Re: **Addendum # 1**
SEABREEZE SHORE REMEDIATION PROJECT
NJDEP - DIVISION OF COASTAL ENGINEERING
PROJECT NUMBER 4248-13

NJDEP Project #4248-13
Seabreeze Shore Remediation Project
Addendum #1: (Q&A) - 9/4/2020

DELAWARE BAY

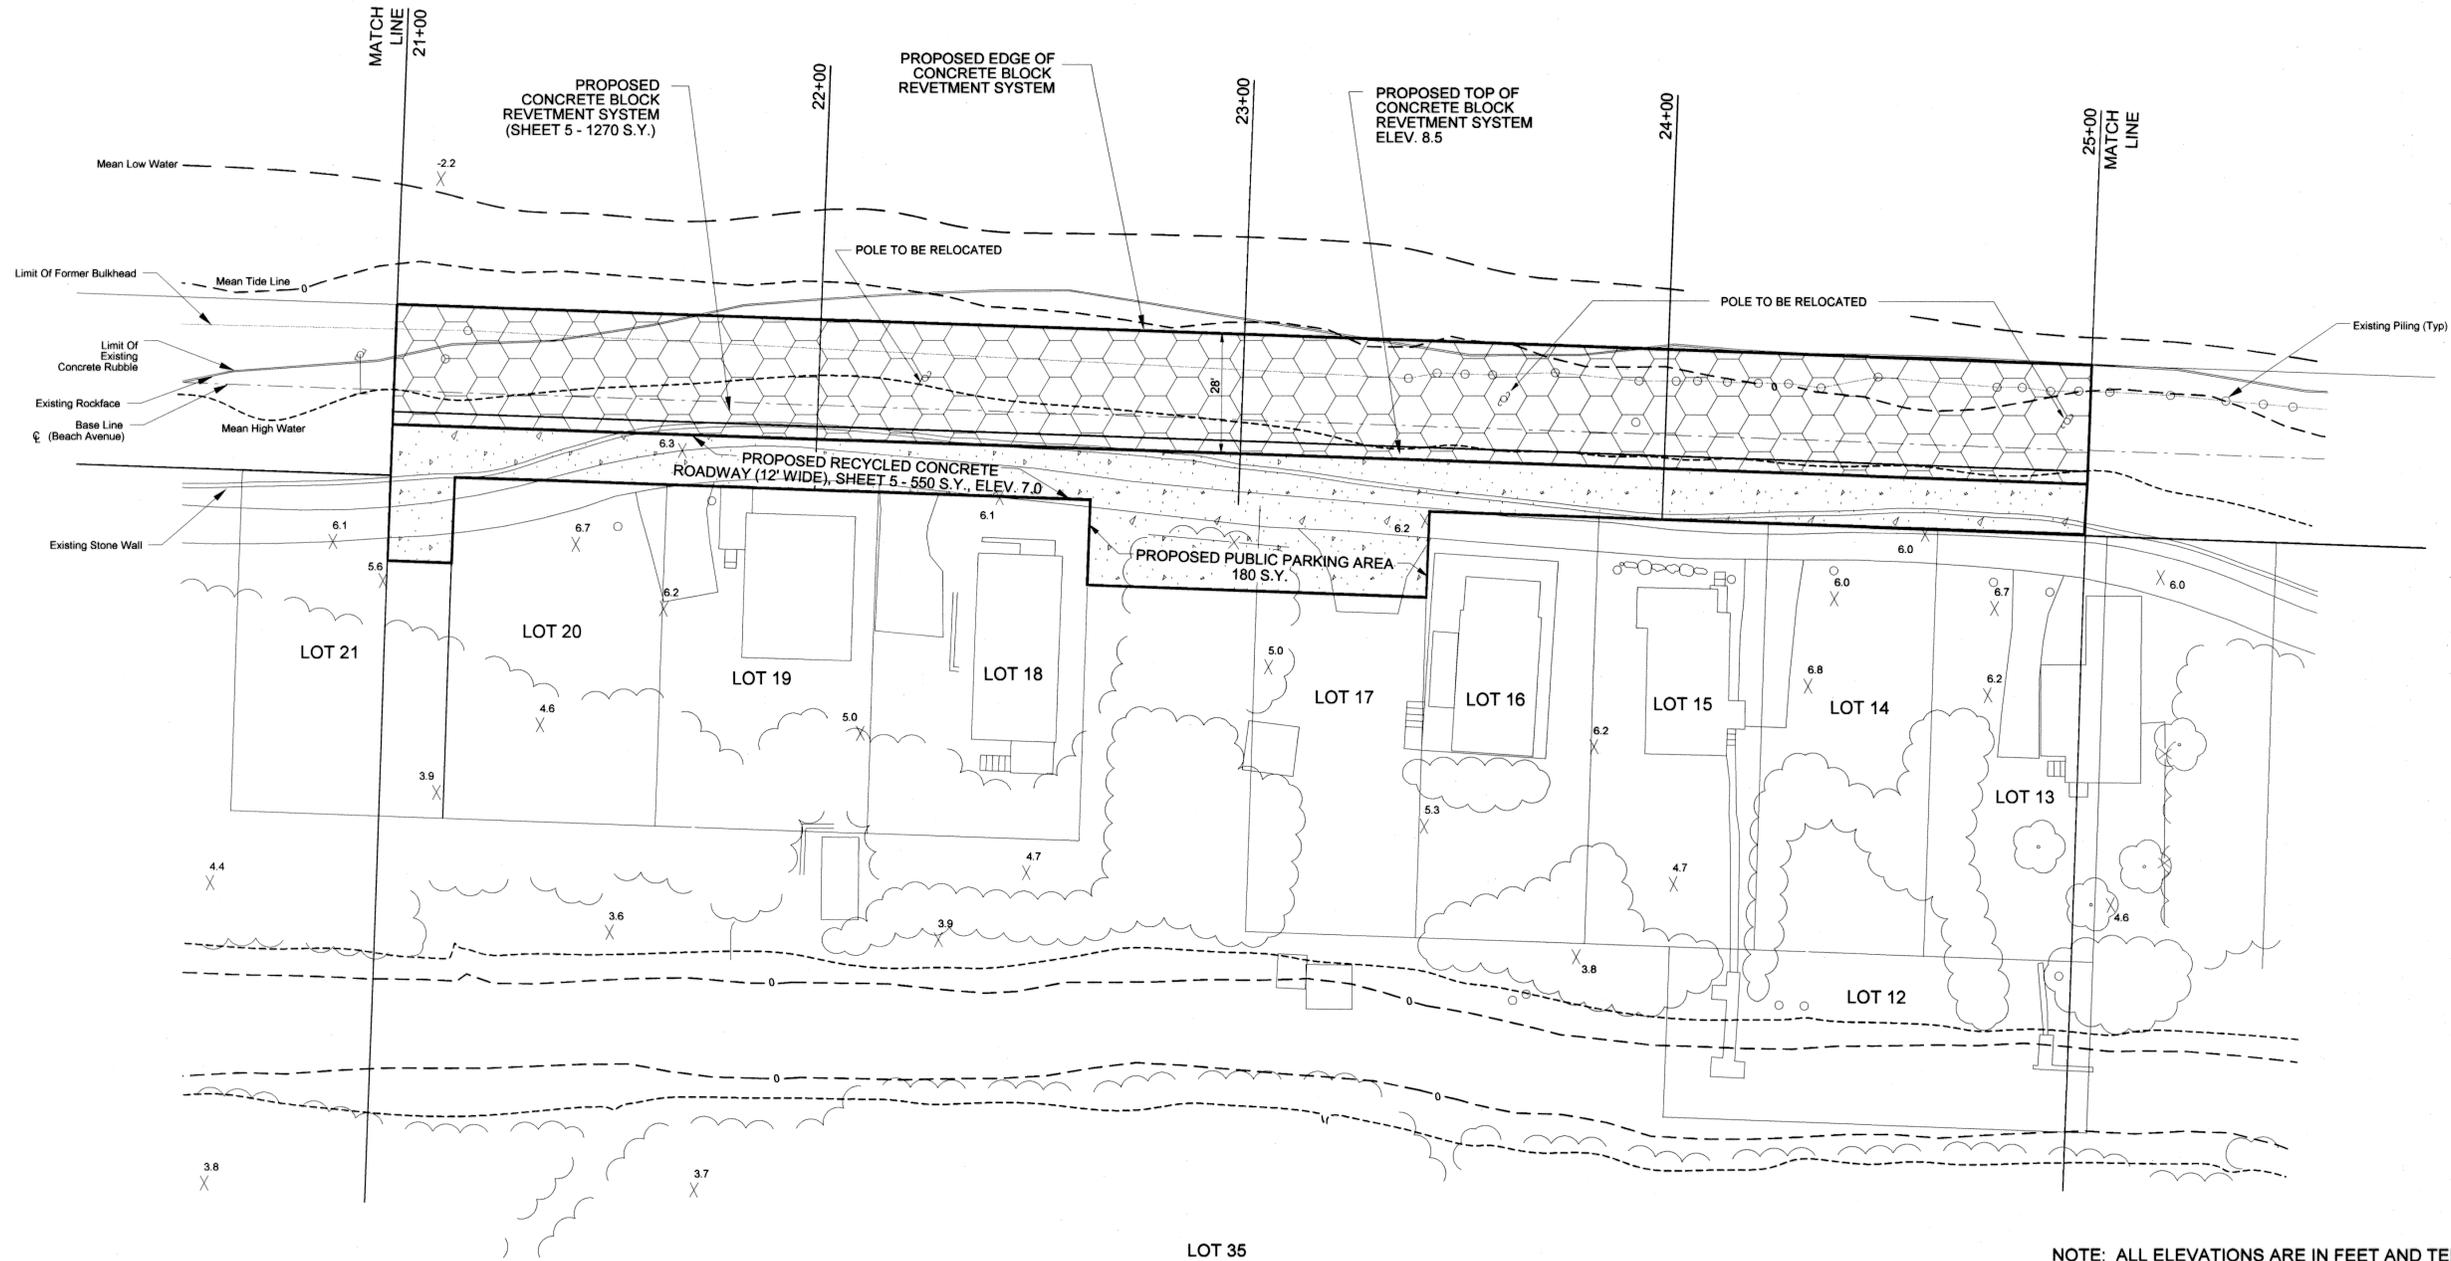
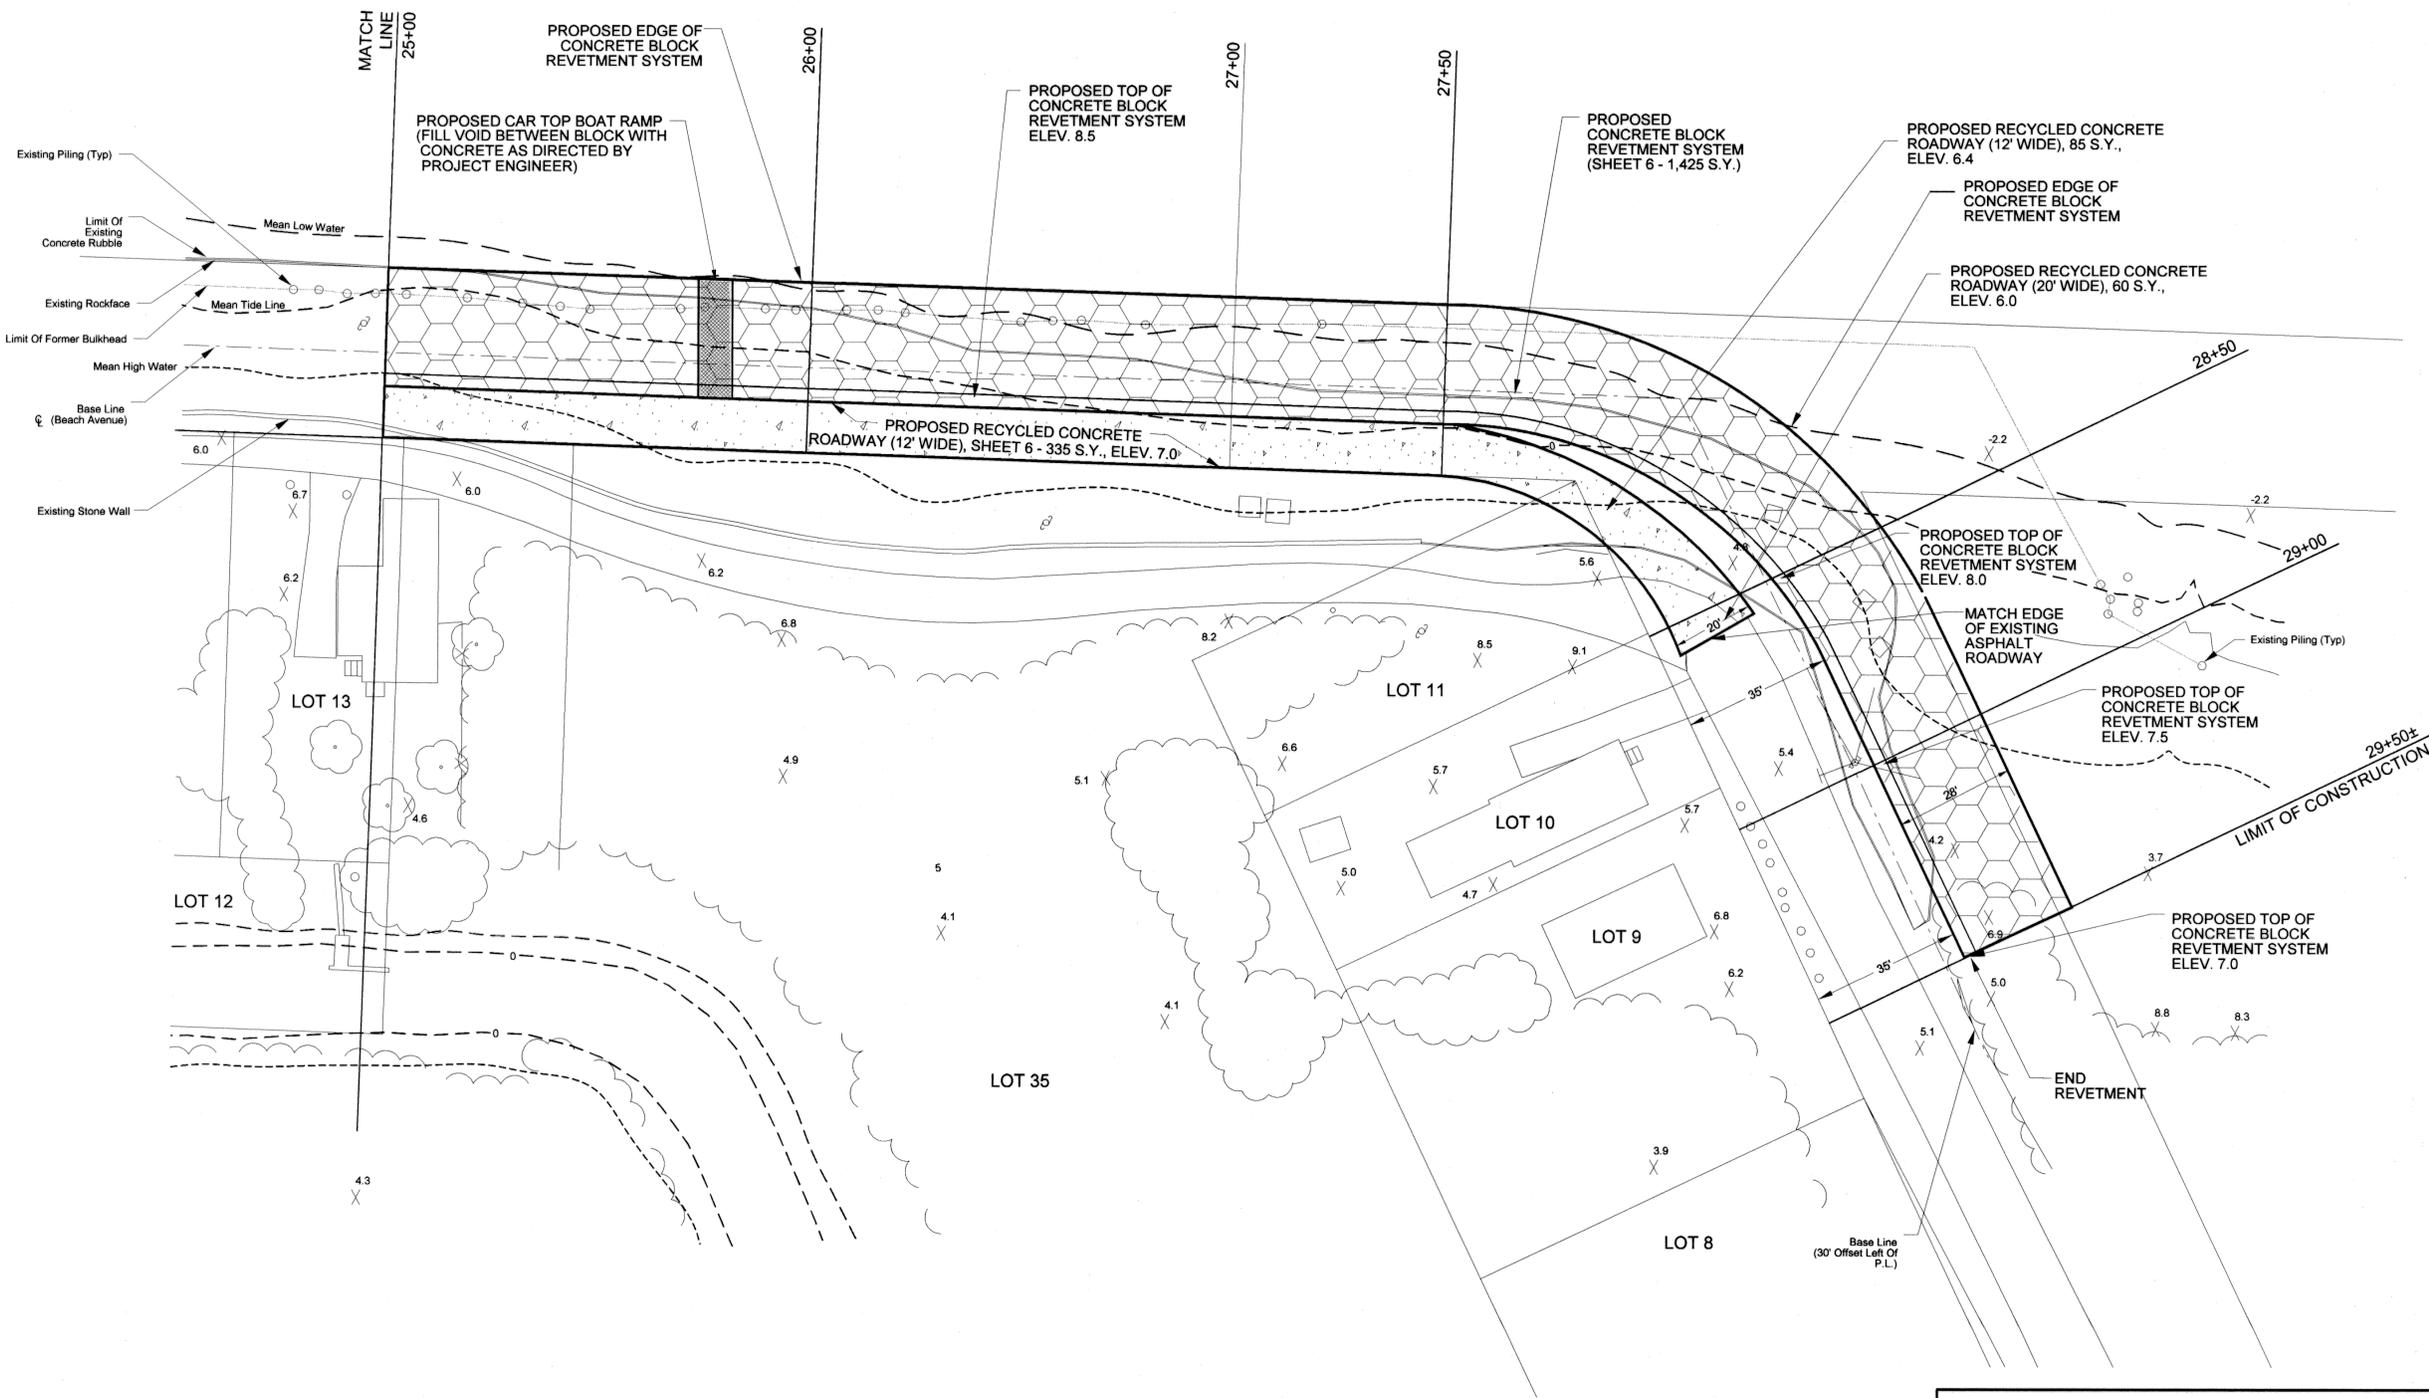
12. How much of the revetment is being left and buried?

A: The only portion of the revetment to remain and be covered with sand is at the turnaround area at the south end of the project (see plans for further detail). All other sections shall be fully removed, inclusive of the toed-in blocks (see Appendix AD1-2, Original Construction Drawings).

TYPICAL SECTION

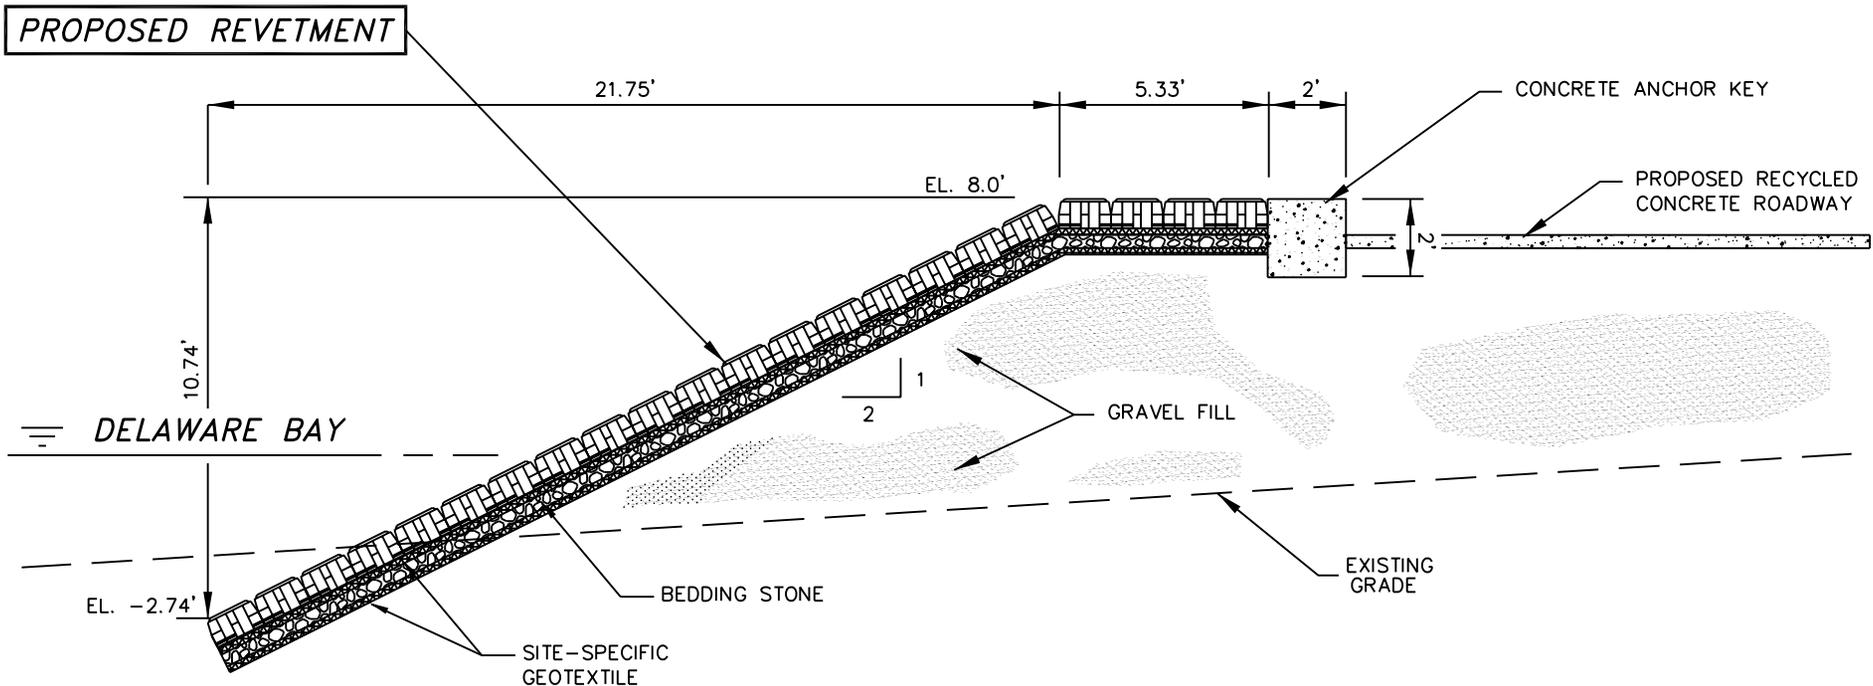
4. What are the soil conditions beneath the wall?

A: I-5, two layers of filter fabric, and ¾" stone was originally placed beneath the revetment (see attached shop drawing – Appendix AD1-3). However, it is unknown how much of this material still exists, as much of it may have scoured out and washed away over the years. The soil conditions beneath the I-5 material is also unknown, but likely a mixture of additional concrete rubble and sand.
